NARWEE PARKLANDS CARE COMMUNITY

SDRP Responding Document

Providing design updates and further clarifications in response to the SDRP meeting held on 12/10/2022

2. SITE STRATEGY + LANDSCAPE

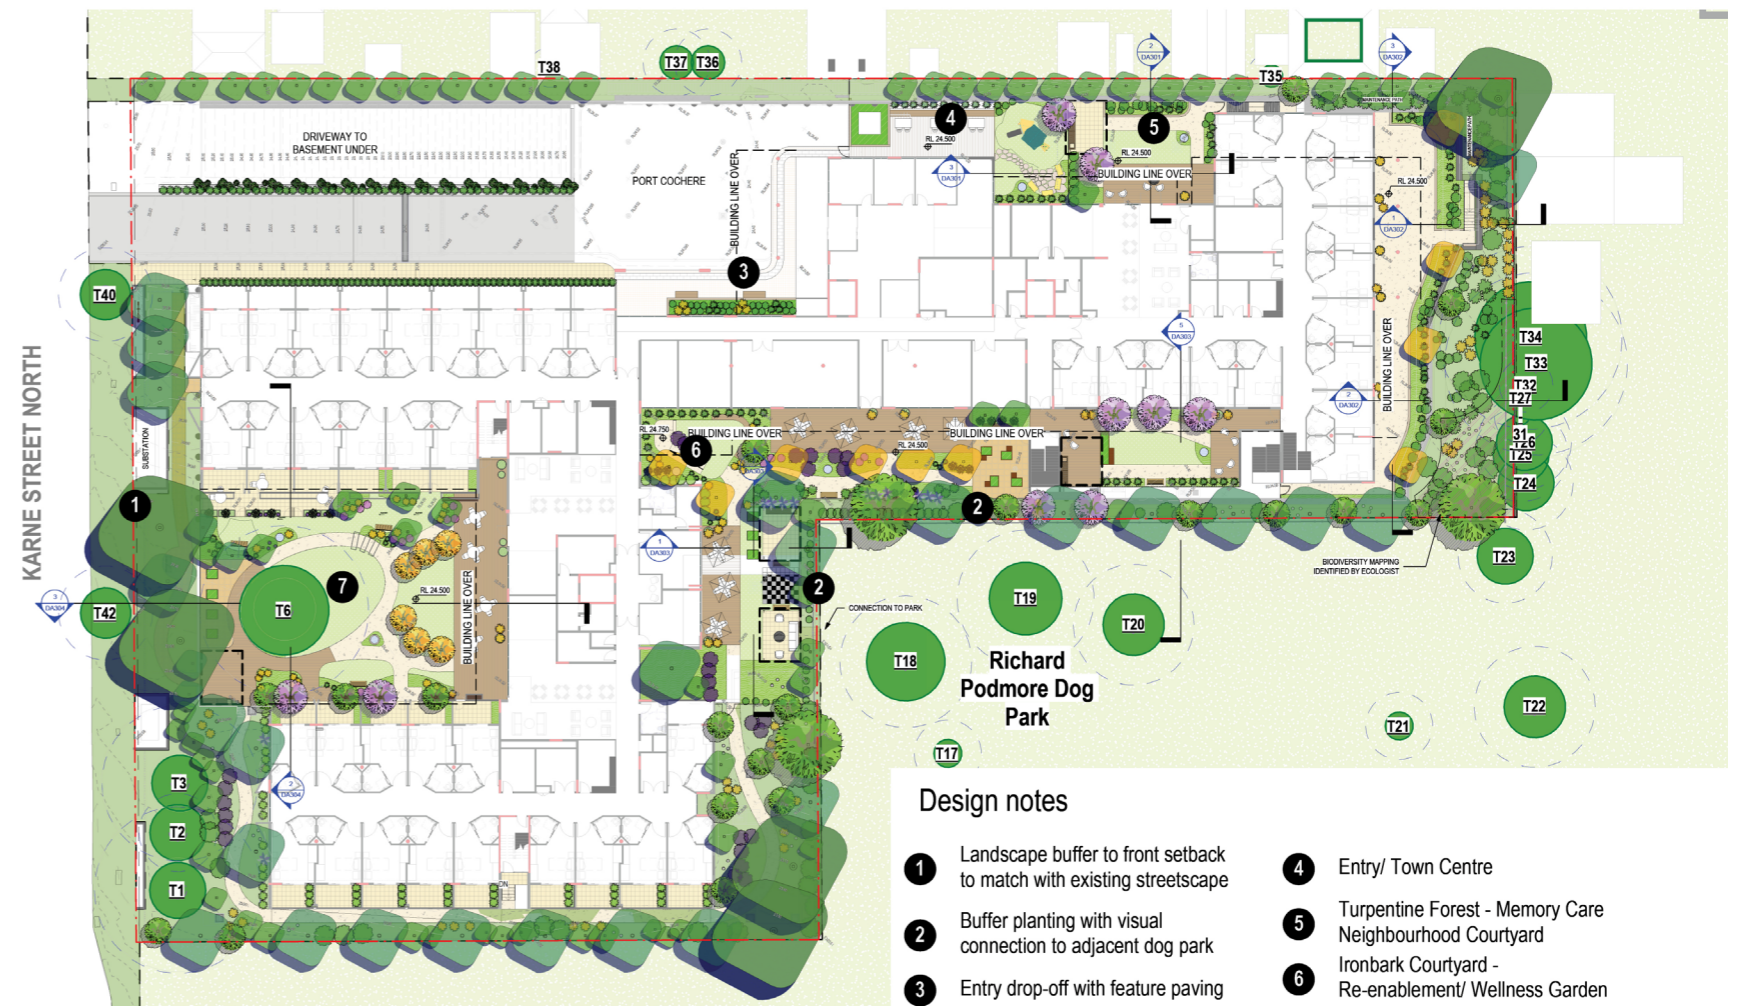
3. The main site entry is dominated by driveways and ramps. Reconsider the north-western interface to improve the arrival experience:
 - a. Investigate the potential to switch the carpark ramp with the ground floor driveway, increasing deep soil provision.
 - b. Increase the landscape buffer to the north of the driveway, to enhance the separation between the neighbouring dwellings and provide a better outlook for the ground floor apartments.
 - c. Incorporate soft landscaping through to the port cochere to reduce the extent of hard pavement.
4. Review the proximity of the elevated protected biodiversity zone, to the eastern ground floor apartment, to ensure the apartment receives sufficient sunlight.
5. Ensure deep soil zones have minimum dimensions of 6m (Housing SEPP, Section 107).

3.
 - a. The Design Team has explored switching the ramp with on grade driveway towards Main Entry. The result is not ideal as Operational is expecting up to 3.8m high ambulance and services vehicles entering the Basement carpark. The closed proximity of ramp will disturb the tranquility and quietness of residents room at Ground Level.

- b. A 400mm landscape strip has been included between the 2 driveways to create green separation for trailing plants to grow on light-weight steel wire mesh. This enhances the overall outlook and separates the proposed design with the residential dwellings. the northern landscape buffer along the site boundary is proposed via increasing to 2m in width to address stormwater design for the development, which allows for the provision of trees to the northern boundary.

- c. Planters with combination of vine/ cascading plants are proposed to the Porte Cochere to provide lush greenery and sense of arrival to the entry. Additional planting area and planting pots are proposed to the drop-off zone to reduce hard paving and highlight the lobby and Town Centre. Planting character to entry area consists of lush and varied planting that evokes a restful character and will be repeated and carried through interiors and landscape courtyards to provide seamless flow throughout the development.

4. The Eastern facade has been further set back from boundary fence line to allow greater depth for sunlight to cast into the resident rooms.
5. Confirming deep soil zones calculation are taken from min. 6m dimensions.
